client:
Simon Payne & Caroline Hayes

architect:
WILLOW
DESIGN PLANNING DELIVERY

issued for:
APPROVAL

drawing title:
Proposed Elevations

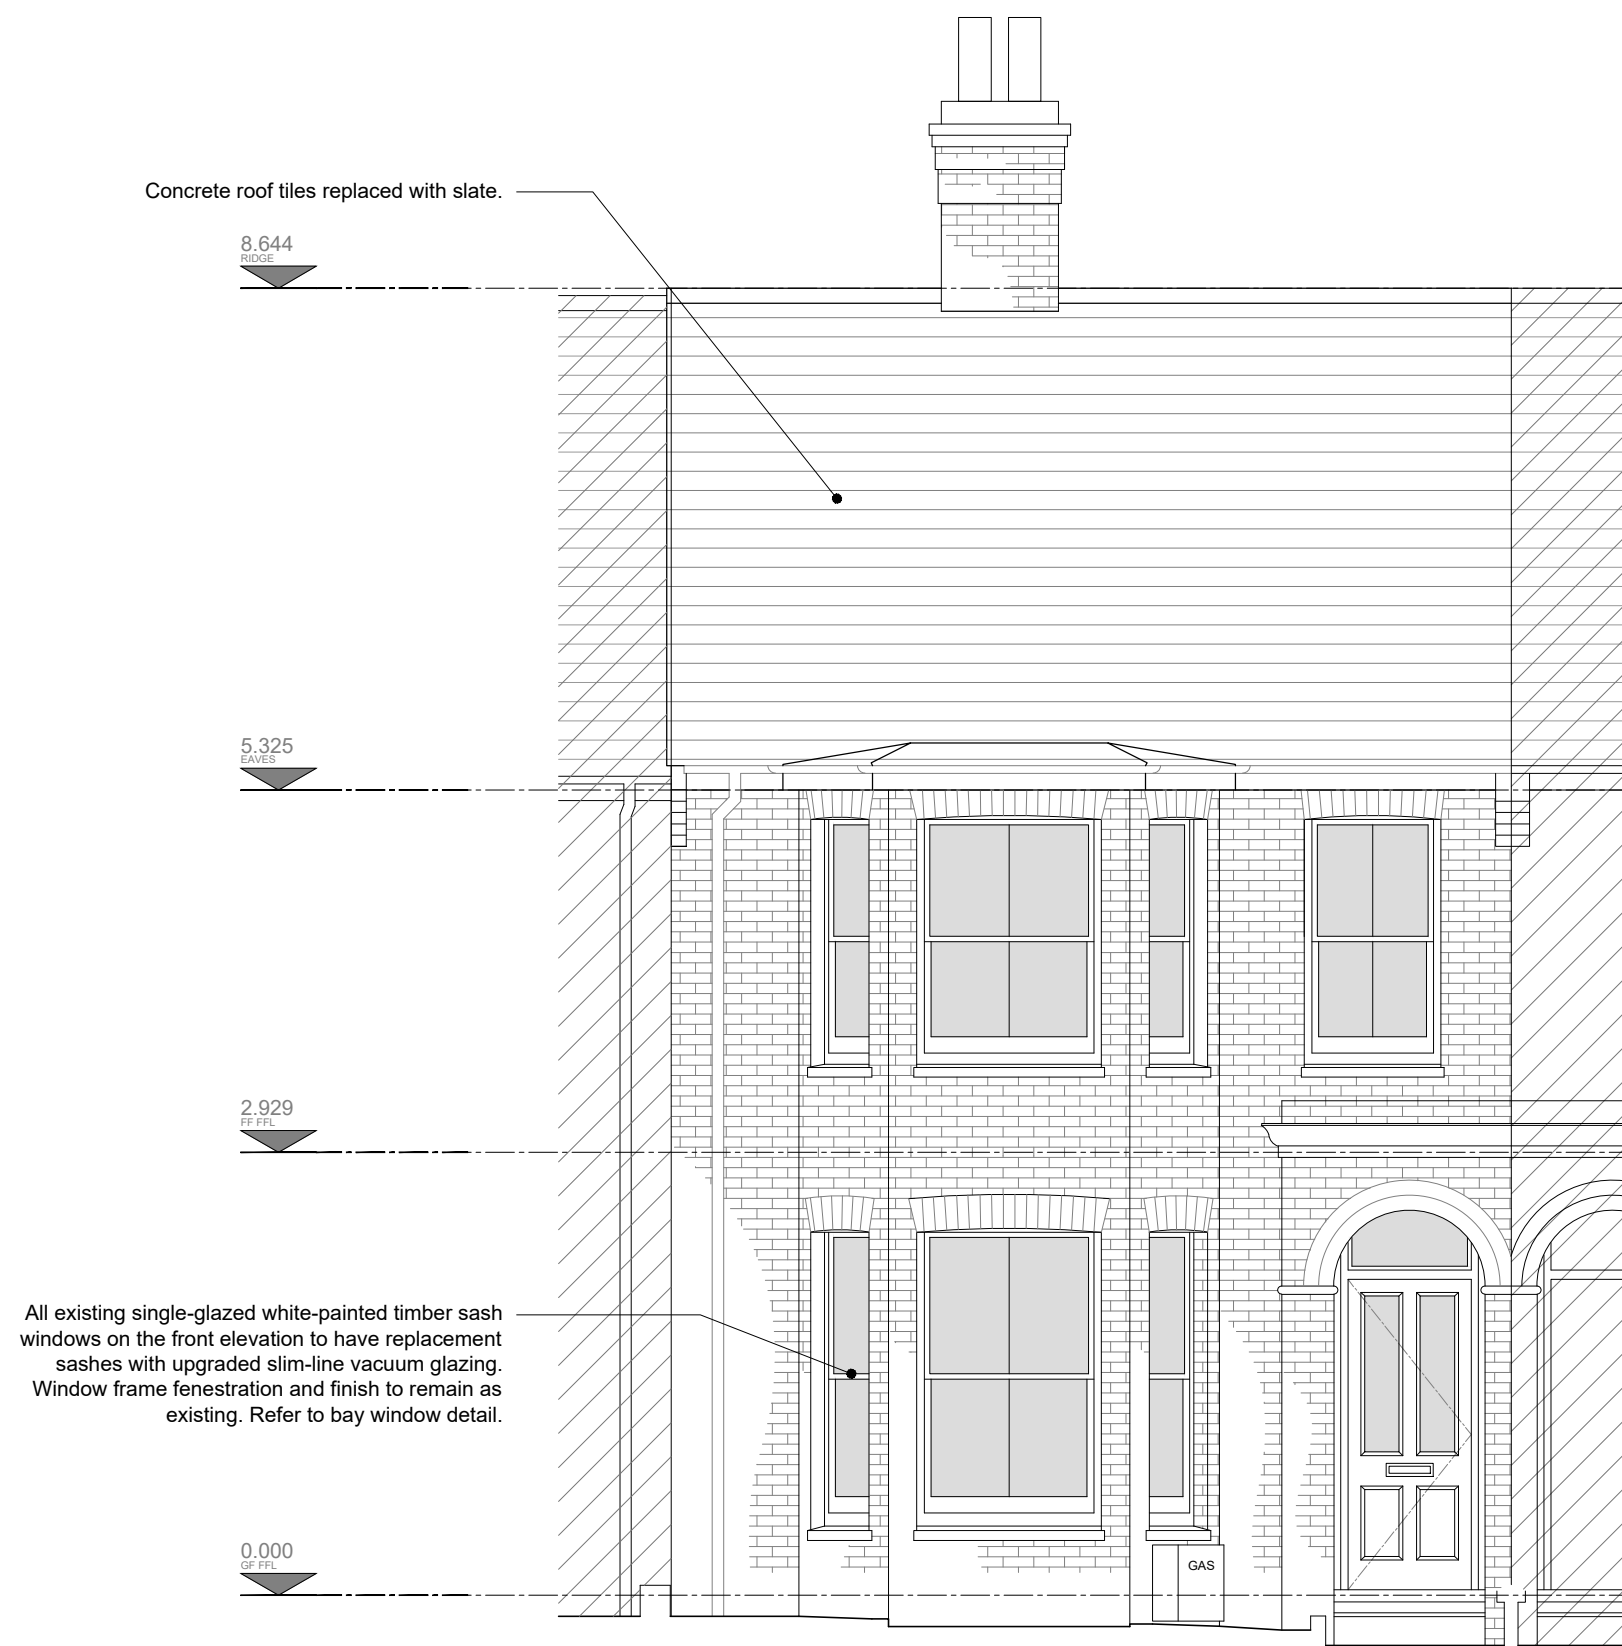
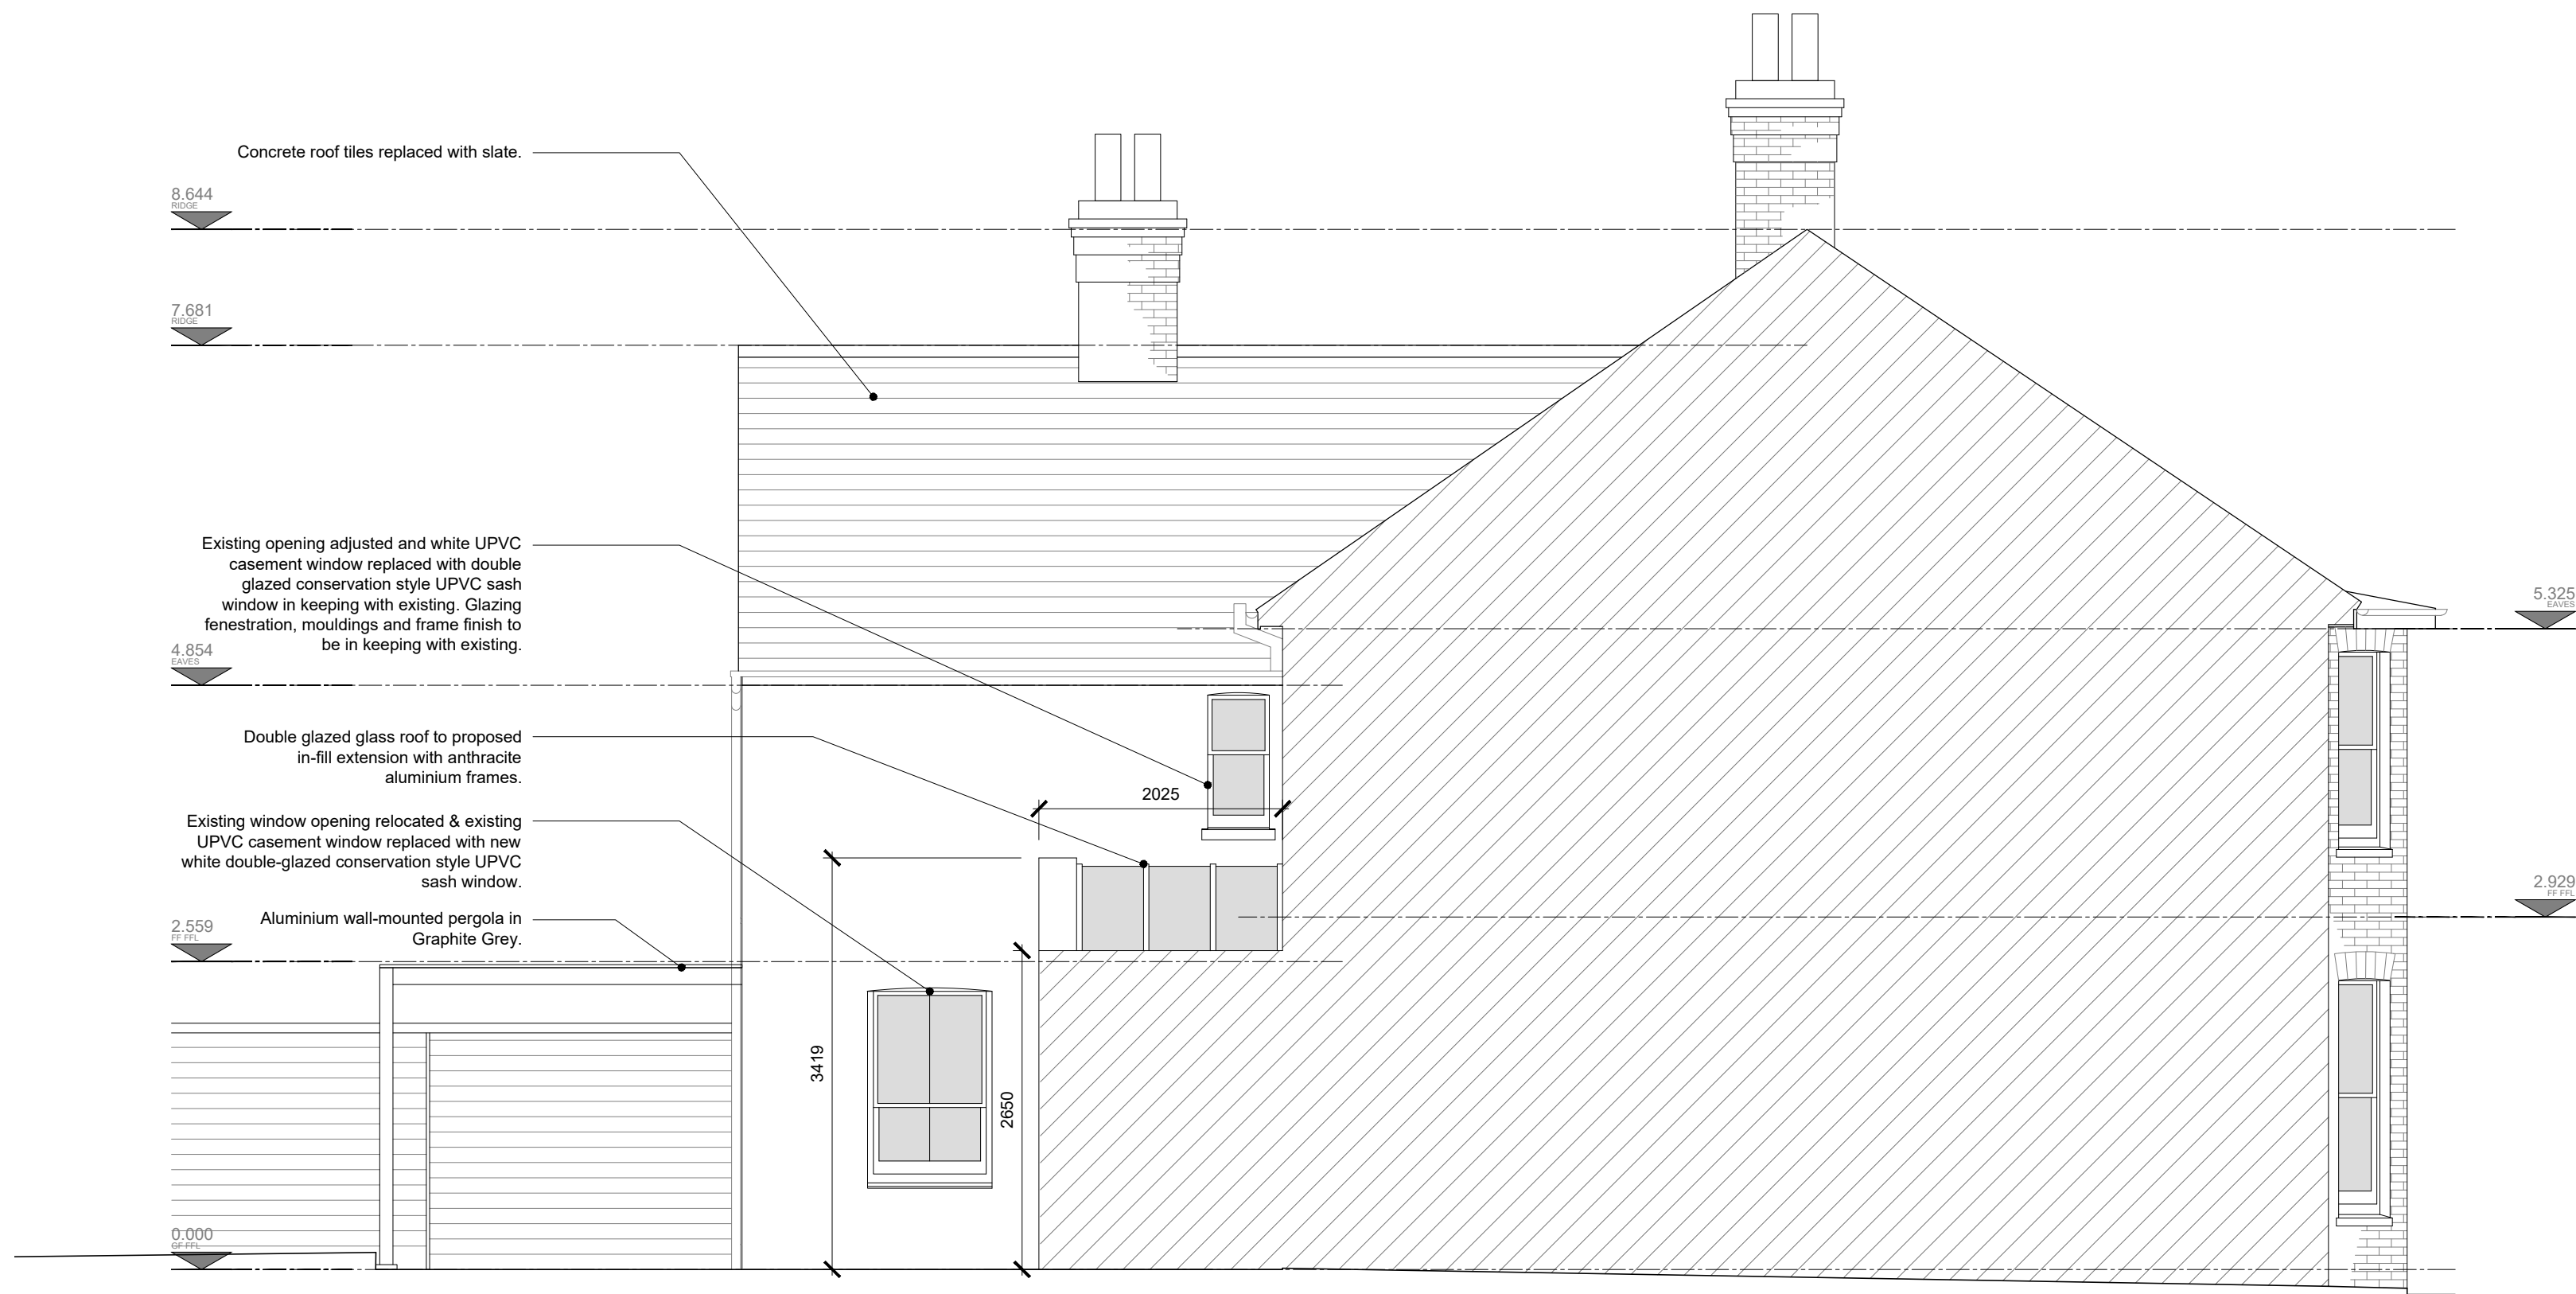
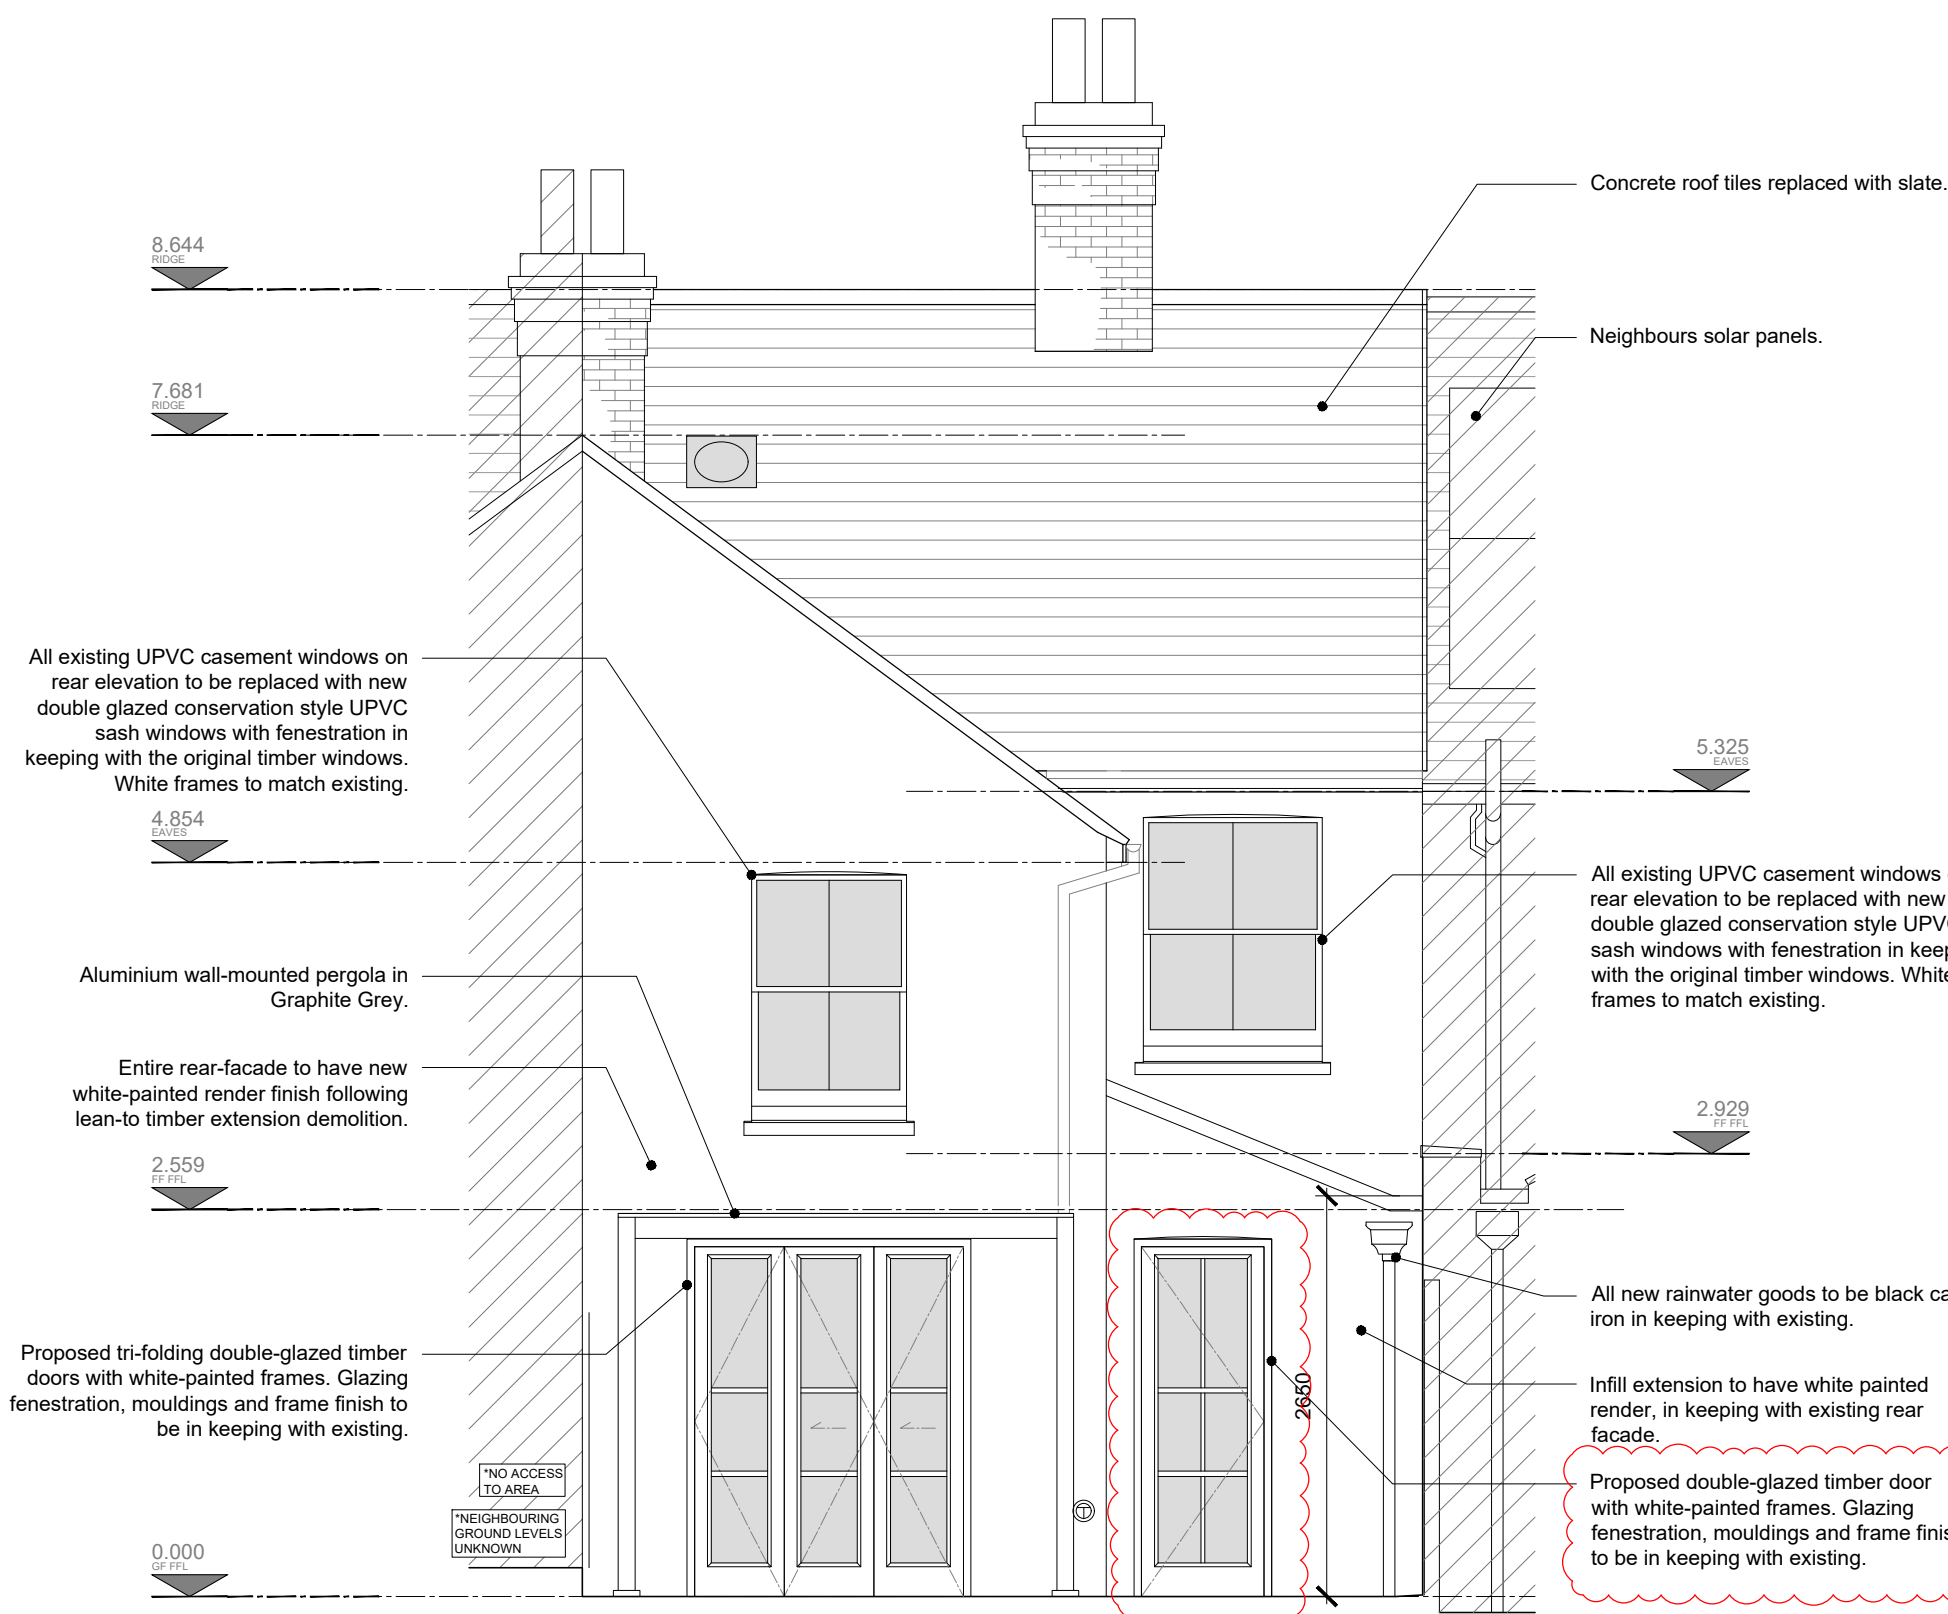
C	02/10/2026	Issued for approval. Variation of condition for french doorset into single door leaf.	SP	LH
B	05/06/2026	Revision in red clouds. Issued for approval. Revised to reflect the latest scope.	SP	LH
A	12/05/2026	Issued for approval.	SP	LH
/	18/03/2026	Issued for information.	SP	LH
